**GENWAL RESOURCES, INC  
CRANDALL CANYON MINES  
C/015/032**

**CHANGE TO:**

**APPENDIX 7-65  
MINE DISCHARGE WATER  
IRON TREATMENT FACILITY**

**IN RESPONSE TO CITATION 10073  
AND  
DEFICIENCIES, TASK 3827  
AND  
DEFICIENCIES, TASK 3941**

<b>AS-BUILT PLAN</b>	
<b>IRON TREATMENT FACILITY</b>	
Crandall Canyon Mines Crandall Canyon P.O. BOX 910 EAST CARBON, UTAH 84520	
DESIGNED BY	PJ
APPROVED BY	DS
DATE	17 OCTOBER 2011
SCALE	1" = 25'
REVISION	2
SHEET	1 of 1

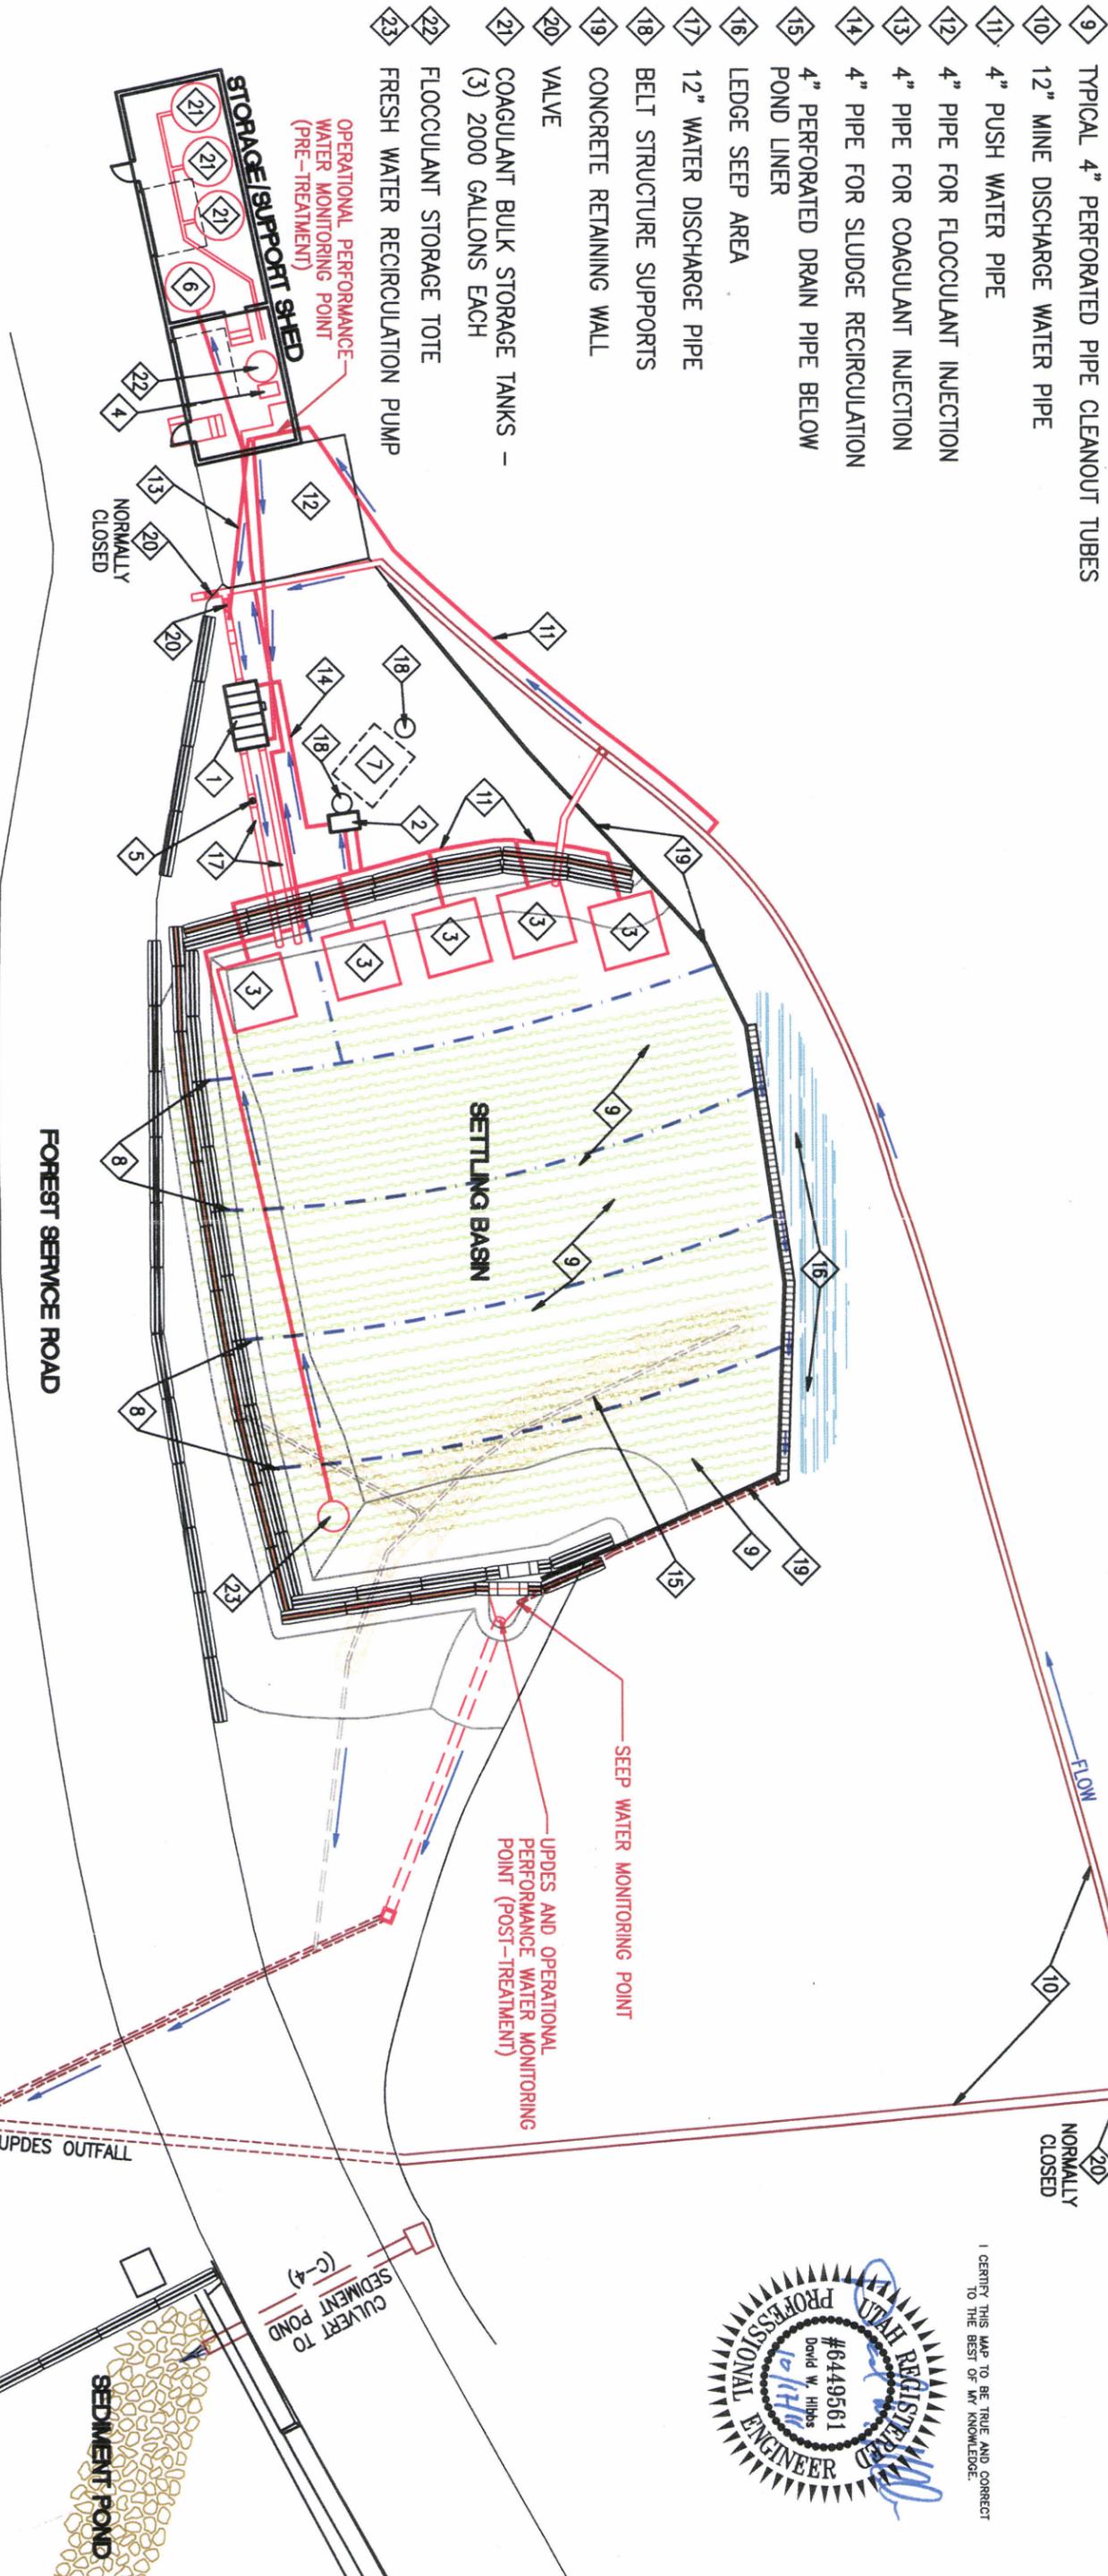
ADD THESE NEW DRAWINGS TO THE OTHER  
DRAWINGS IN ATTACHMENT 8 OF APPENDIX 7-65

DRAWN BY	PJ	SCALE	NONE
APPROVED BY	DH	DATE	17 OCTOBER 2011
REVISION	2	SHEET	1 of 1

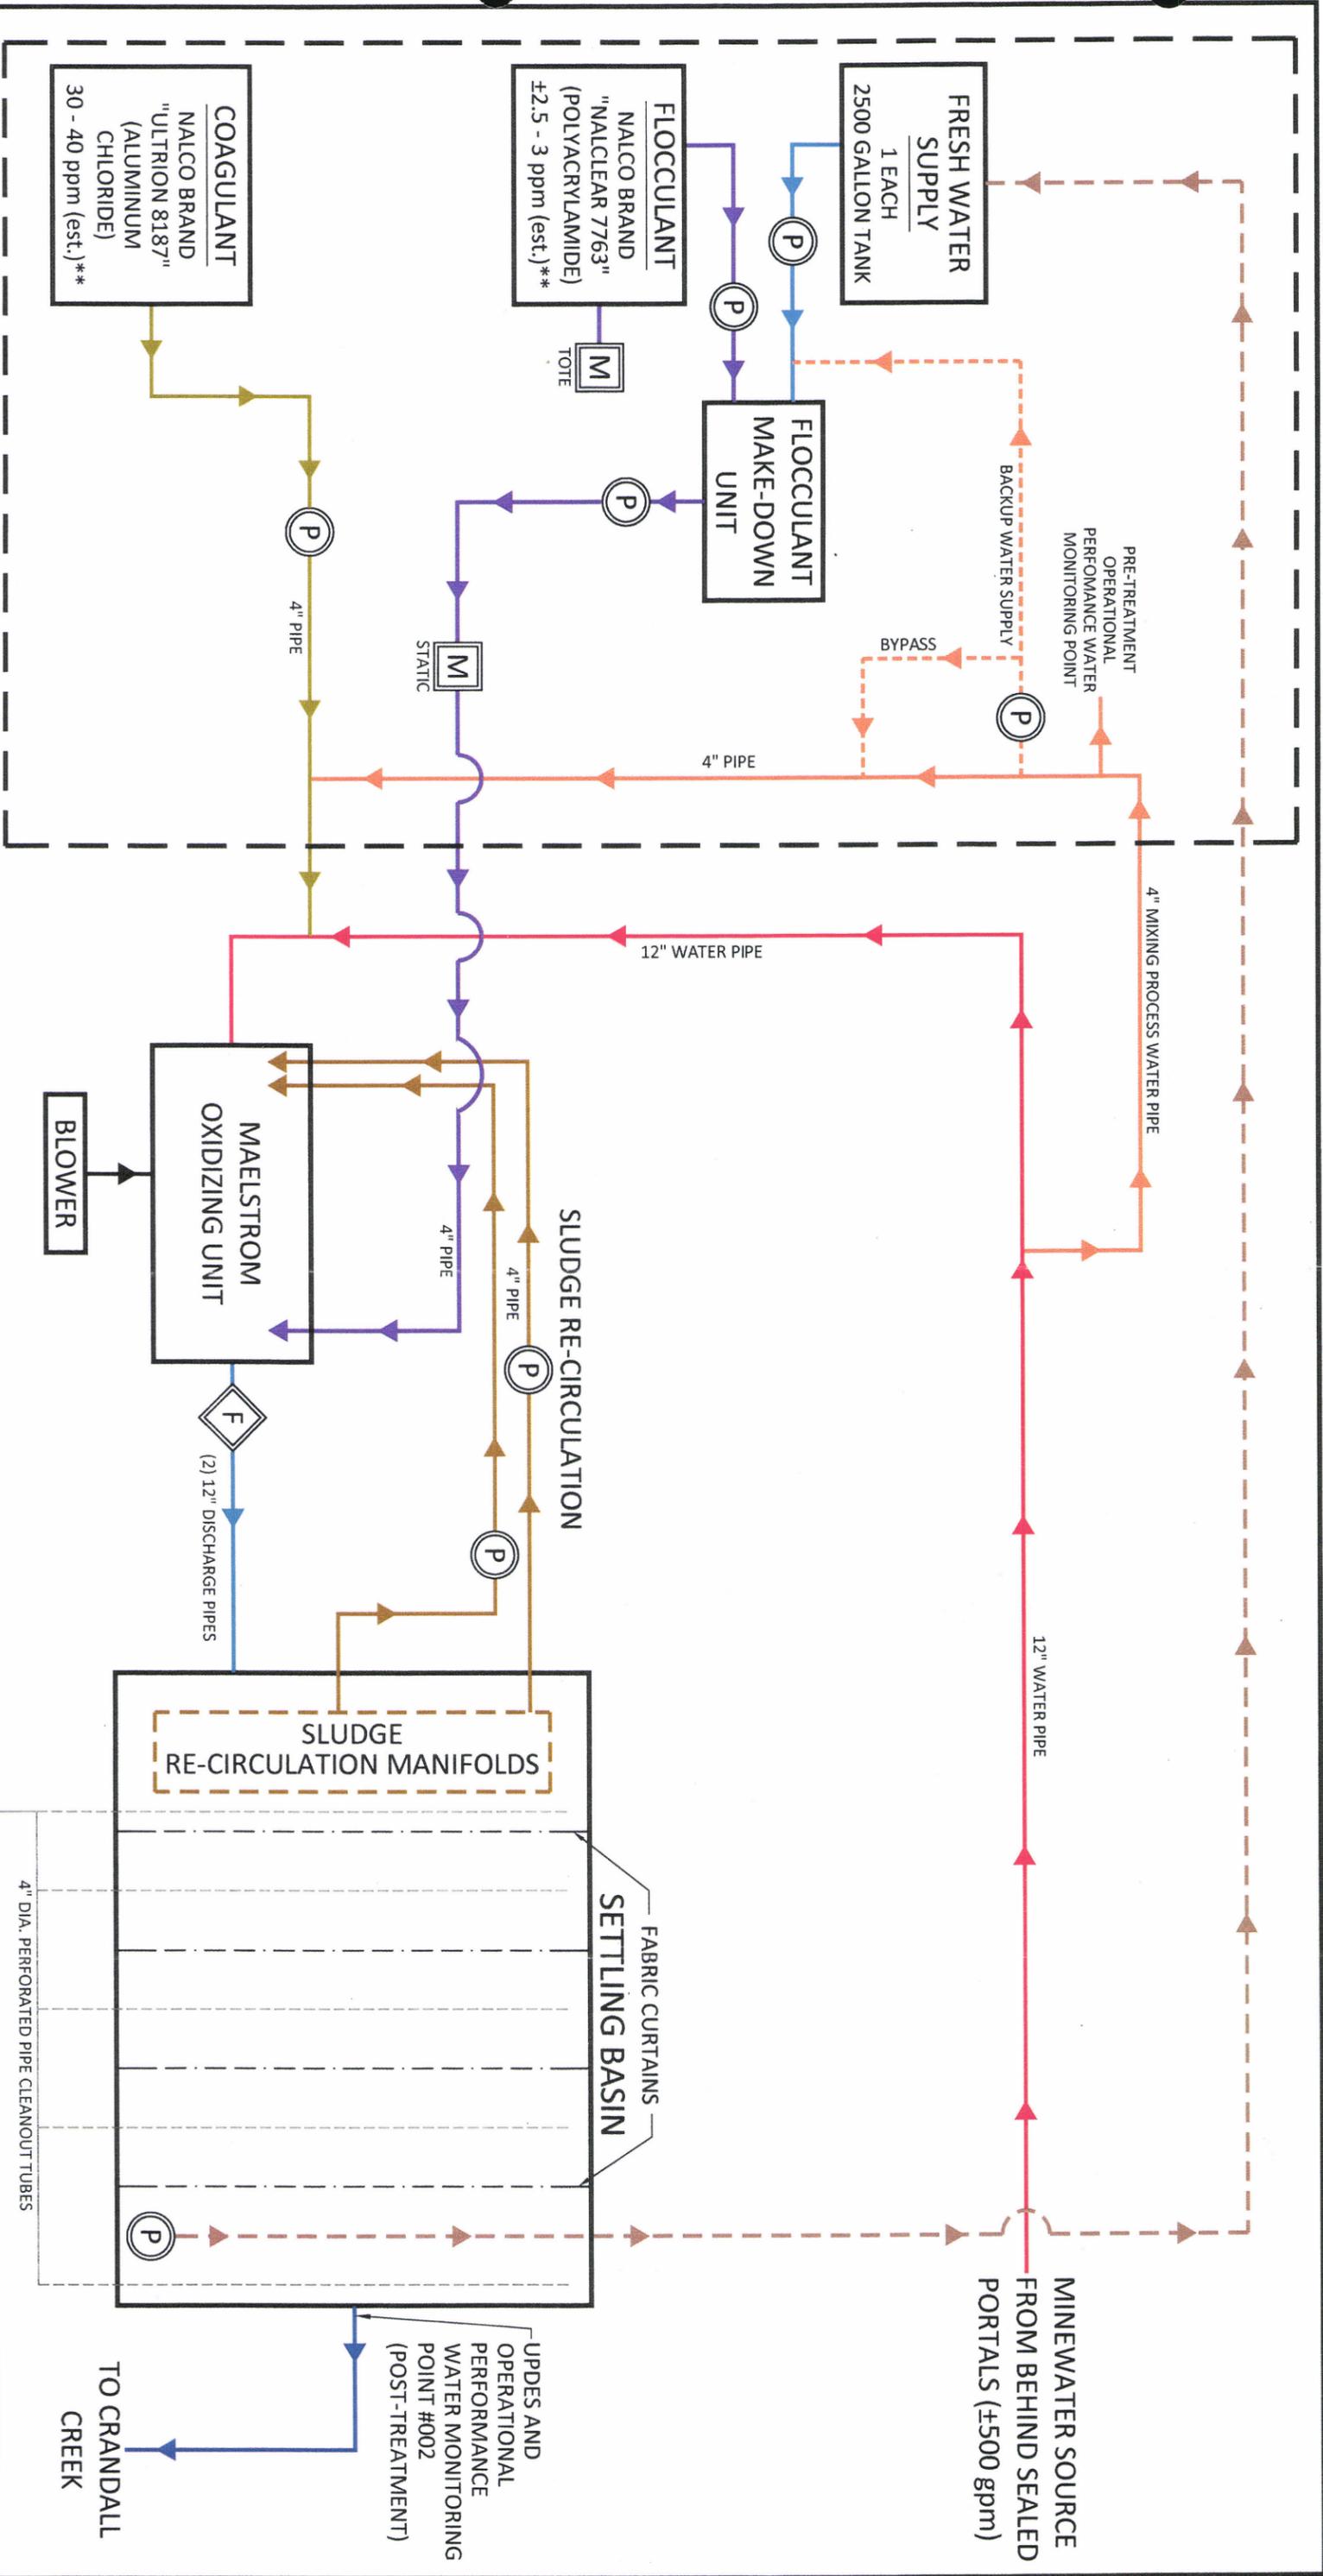
\*\* CHEMICALS ARE CURRENT AS OF OCTOBER 2011. DOSAGE RATES ARE APPROXIMATE. CHEMICALS AND RATES MAY CHANGE IN THE FUTURE BASED UPON TRIAL TESTING RESULTS, AND IMPROVED MECHANIZATION AND CONTROL.
